Los Angeles County
Department of Regional Planning

Project No. R20124-01529-(4)
Zone Change No. 201400008
Vesting Tentative Parcel Map No. 072916
Conditional Use Permit No. 201400062
Parking Permit No. 201400006
Environmental Assessment No. 201400121
Agenda Item: 7

The project is to subdivide 14.85 gross acres (13.3 net acres) to create three parcels developed with two hotels and 155 commercial retail condominium units within four detached structures in Rowland Heights.

Re: Rowland Heights Plaza and Hotel Project
Project No. R2014-01529-(4)
Environmental Assessment No. 201400121

Photo 1

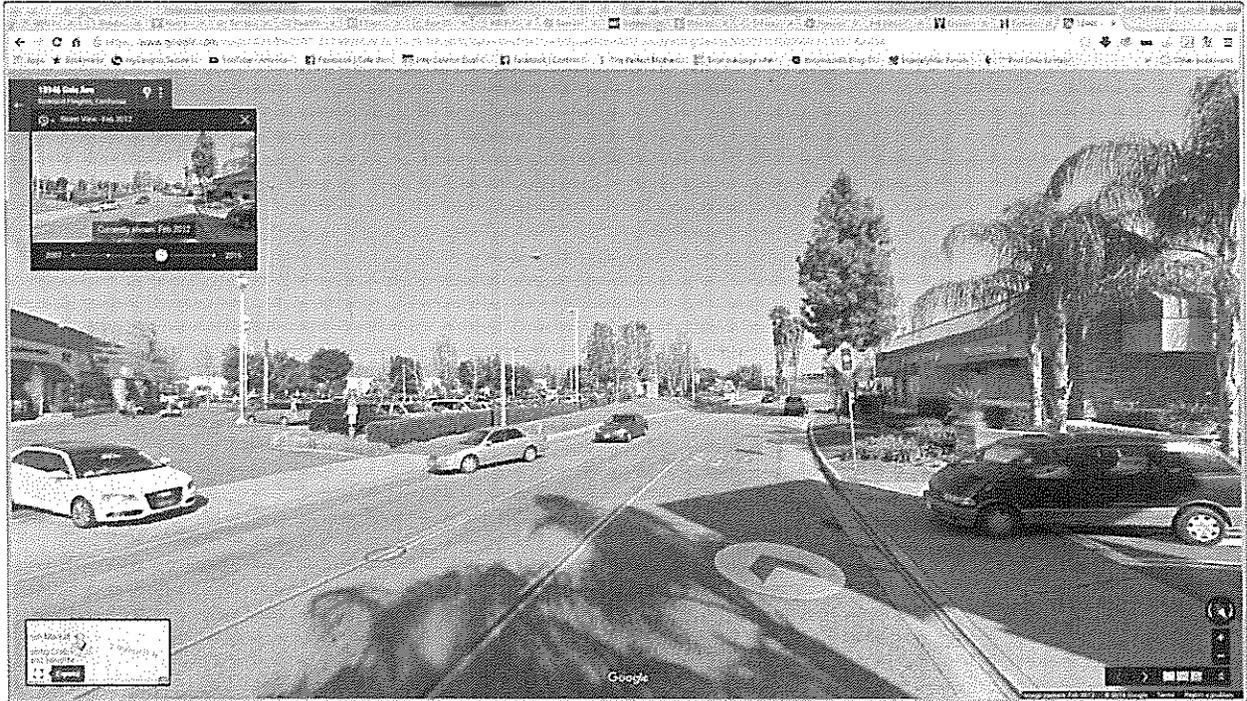
- (A) In 2013, 99 Ranch Market Shopping Center had 3 driveways on Gale that allowed access to Gale, for both east and west bound. Access Road did not exist at that time. *(Please see Photo 1 and 2 attached)*. After ACE Construction, Gale Avenue now has 2 lanes each for east and west bound, but has a concrete median that prohibits left turns into and out of 99 Ranch Market; consequently, all Gale eastbound traffic entering 99 Ranch Market and all traffic exiting 99 Ranch Market and going Gale eastbound must use Access Road, which replaced one of the 3 driveways 99 Ranch Market had before 2013. *(Please see Photo 3 attached)*. In 2015, when Applicant's consultant collected additional traffic data pertaining to 99 Ranch Market on September 9 and September 12, 2015 while Nogales Street and Gale Avenue were still under construction. The raw data was provided to us but analysis was never conducted utilizing those data, and those data was never made part of EIR appendix. At that time, Nogales was closed to traffic and Gale had 4 lanes but with intermittent lane closures, 99 Ranch Market only had 2 driveways available for ingress and egress at that time and saw significant reduction in traffic into the shopping center. *(Please see Photo 4 attached)*. Applicant conducted analysis on October 8, 2015 related to Gale and Access Road intersection *(identified as Intersection #8 in Project traffic analysis)* using data that shows Saturday Peak Hour at 93 southbound left to Eastbound Gale and 96 southbound right to Gale westbound, a total of 189 vehicle trips from 99 Ranch Market utilizing Access Road (the actual count sheets are missing from the EIR appendix). However, when we collected our own data on August 20, 21 and 26, 2016, less than 3 months after Nogales Street was reopened for traffic (please see attached August 20, 2016 ITM Peak Hour summary prepared by NDS), it shows 201 southbound from Access Road to eastbound Gale and 46 southbound from Access Road turning right to westbound Gale, a total of 247 vehicle trips from 99 Ranch Market utilizing that Access Road, a very significant increase of traffic turning to eastbound Gale compared to Applicant's 2015 data used in the analysis. Due to Applicant's inaccurate data, traffic analysis on Access Road resulted from those data should not be accepted and new analysis based on 2016 data should be conducted.

Access Rd and Gale Ave, Rowland Heights

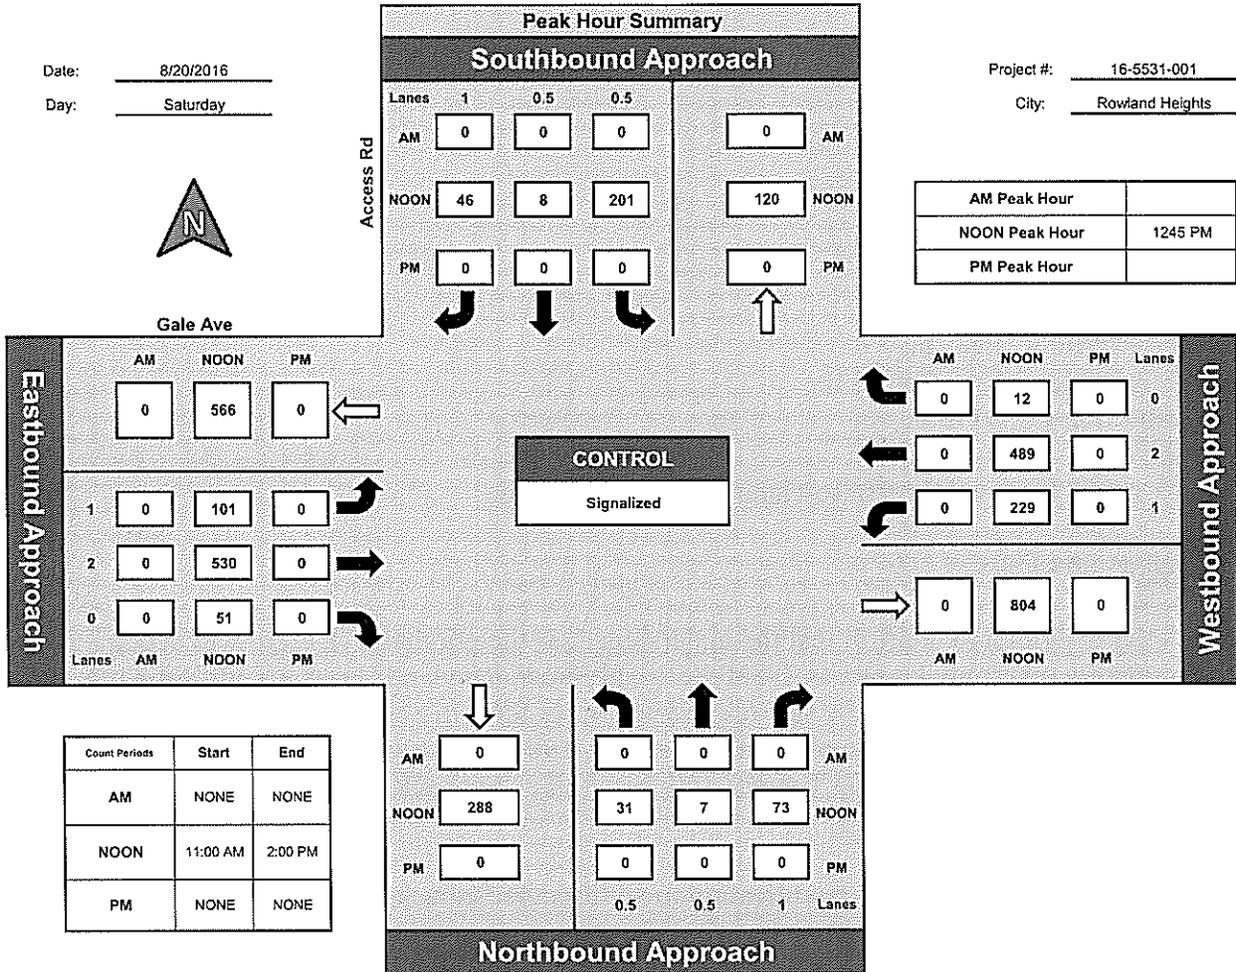
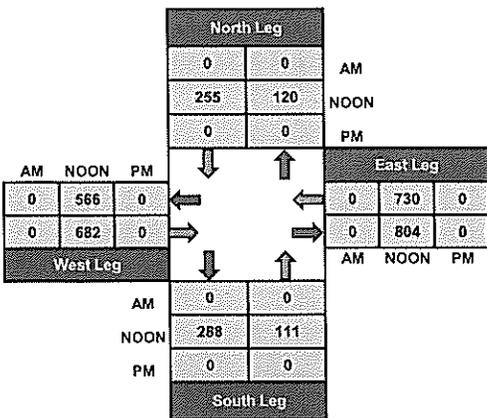
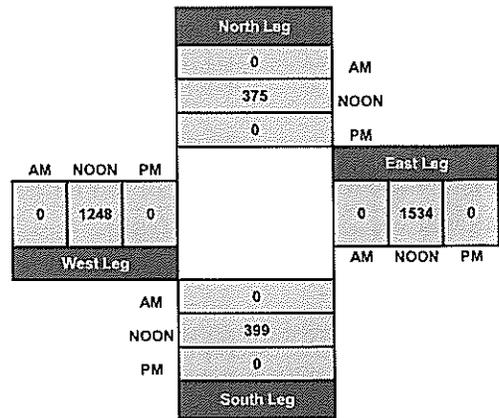
- (B) Applicant's analysis on Intersection #8 referred to in section 4(b) above, utilizing inaccurate data collected in 2013 and 2015, is only about how much traffic can travel through that Intersection under ideal circumstance; it does not take into account the severe impact on the efficiency of that Access Road caused by complicated ingress and egress patterns at the cul-de-sac of that Access Road created by Applicant's plans. In addition to exiting access to 99 Ranch Market, the Project proposed 2 new accesses, one serves as the main entrance to the Project, the second one enters directly into one of the Project's underground parking structure. On the proposed plans, the three access points will have a stop sign when exiting, ingress traffic will have right of way to all 3 access points. Egress from the Project's main entrance will have priority after ingress traffic, due to the fact that they are making a right turn on to Access Road, they can

Figure 2 Site Plan

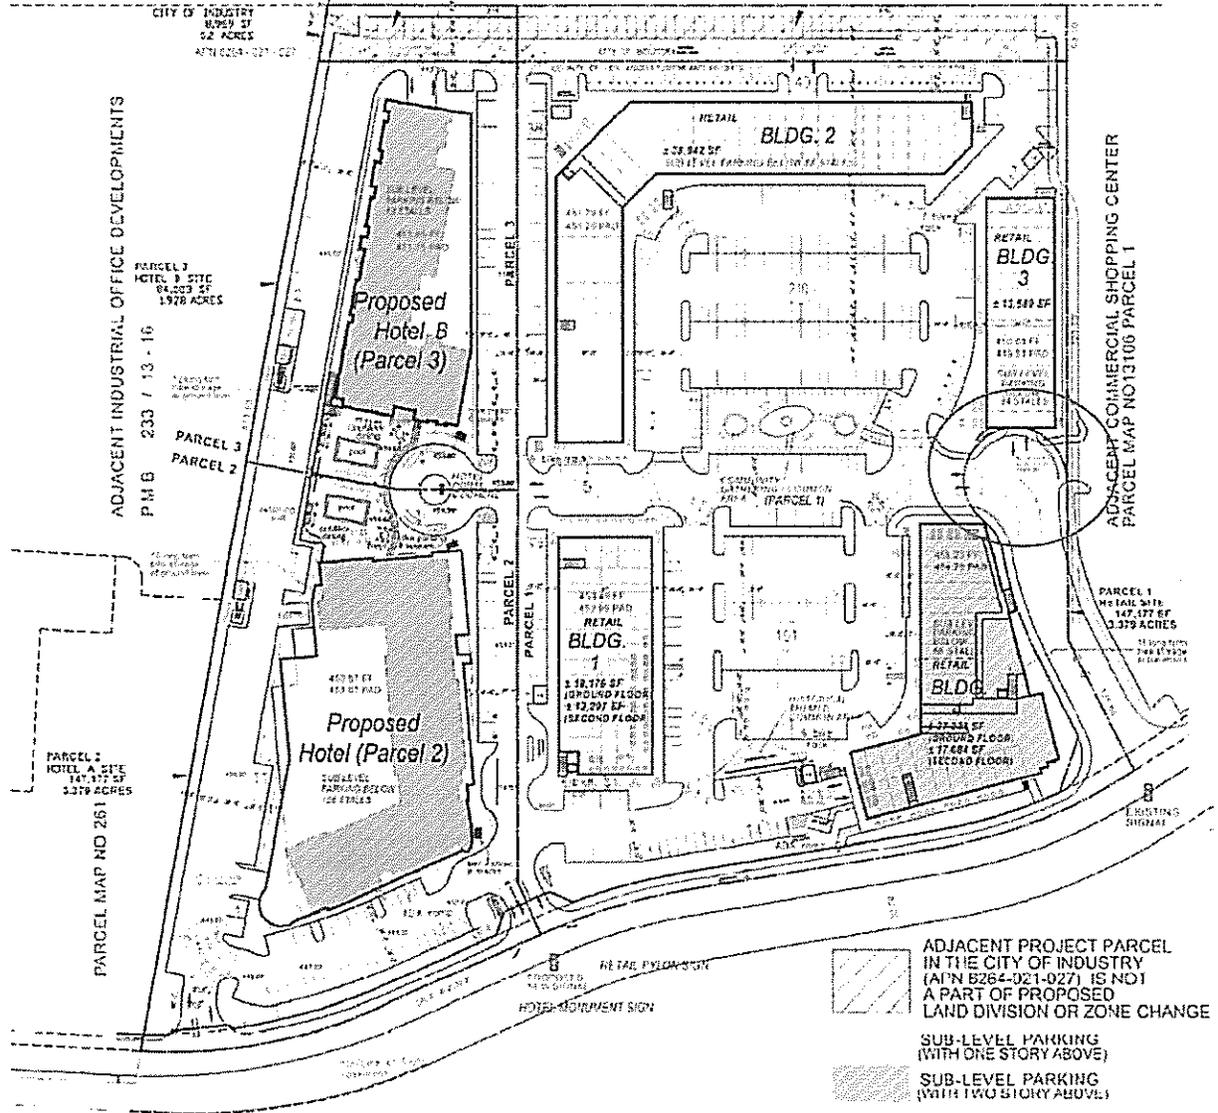
The Applicant was made aware of a 22 feet setback restriction at the east boundary of the Project in January 2016. Instead of modifying development plans to comply with such restriction, the Applicant has elected to proceed with plans and maps that do not comply with the setback restriction, but promised to modify plans to address the setback restriction after EIR is certified and permits are granted (*Please see August 24, 2016 letter from Parallax Investment Corporation attached*). FEIR should reflect the actual development plans before it is certified, and modifications after certification of FEIR should only be reserved for issues that surface afterwards, not those can be addressed before certification. Since the plan modifications very likely will change the building square footage and parking spaces provided in the Project, both are significant elements of an EIR; and given the fact that there was enough time for Applicant to make the necessary plan modifications prior to the public hearing and consideration of FEIR, Applicant should be required to make the necessary plan modifications and amend the FEIR as needed before certification is granted.
